Prairie Island Nuclear Generating Plant
Docket No. 50-282 License No. DPR-42
Docket No. 50-306 License No. DPR-60

Detailed Control Room Design Review Status Report
and Response to March 1984 In-Progress Audit

Appendix A
In-progress Audit Report Concerns/Recommendations Response

FIGURE A1

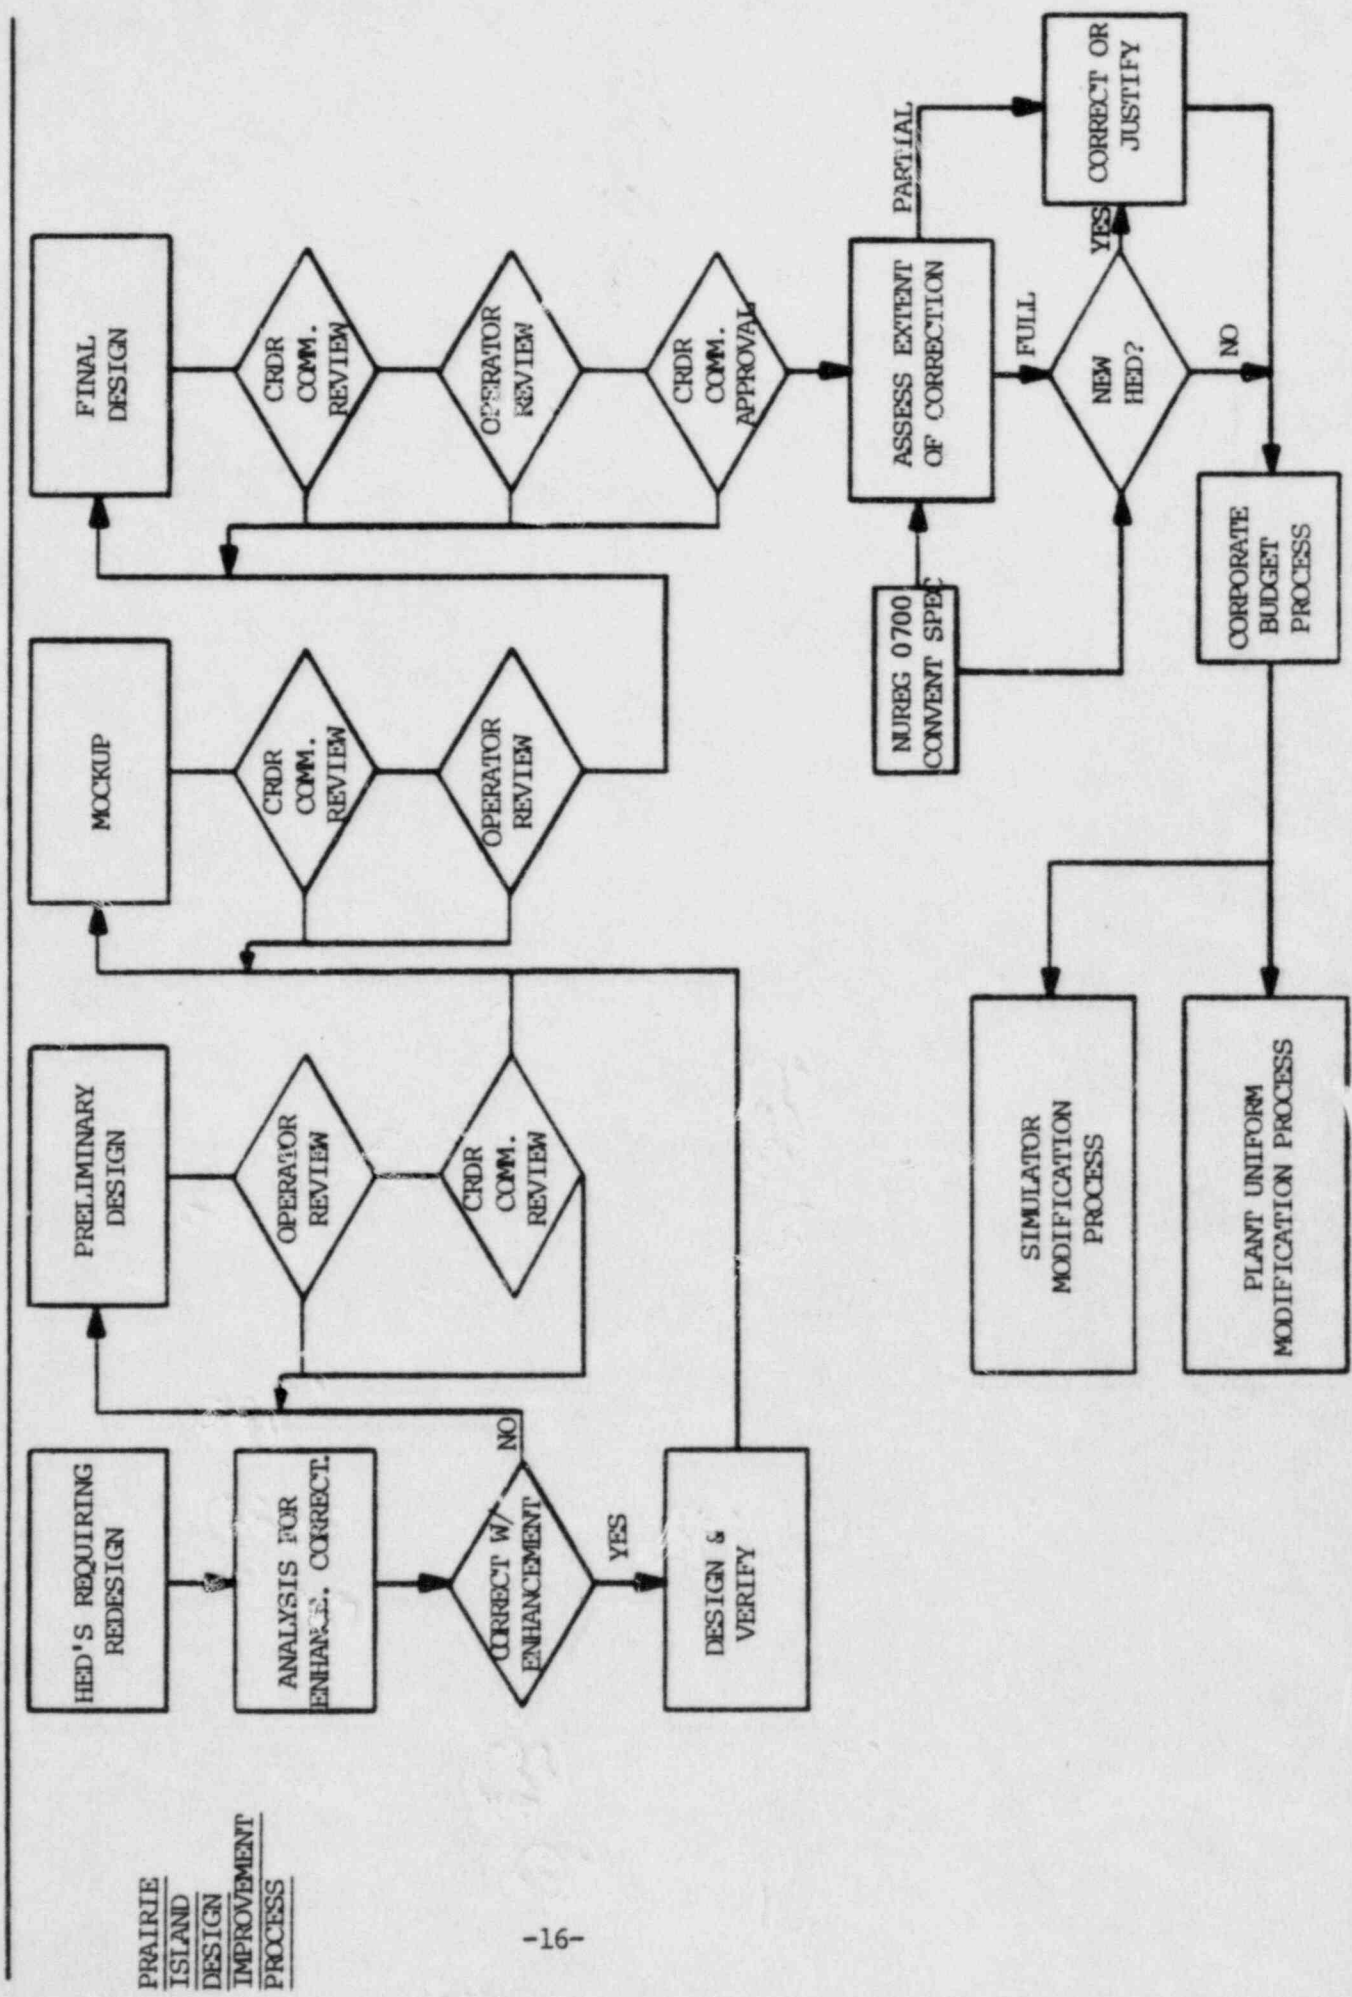
3. Use the control room mock-up(s) to assess the integrated effect of the fullest range of design improvements and enhancements possible (to include labeling and demarcation).
4. Continue to assure participation of an adequate mix of personnel (including operators and human factors professionals) throughout assessment of HEDs and the development and evaluation of design improvements.

5. Coordinate modifications to the control rooms and simulators in a way that will enhance, not degrade, operator performance.

Response: Figure A-1 is a description of the process used for the Prairie Island design improvements. A summary for the design improvement recommendations methodology is:

1. Prepare preliminary concept design for retrofit of existing design or new design effort.
2. Evaluate resolution of HEDs pertaining to old design.
3. Implement design concept on mockup to correct scale.
4. Conduct preliminary design review:
 - o Human factors
 - o CRDR Committee
5. Perform NUREG 0700 checklist and/or survey review of revised design.
6. Conduct walk-through talk-through of EOPs related to revised design.
7. Assess safety consequences of new design.
8. Conduct final design review:
 - o Operating staff
 - o CRDR Committee
9. Obtain final design and budgeting approval.
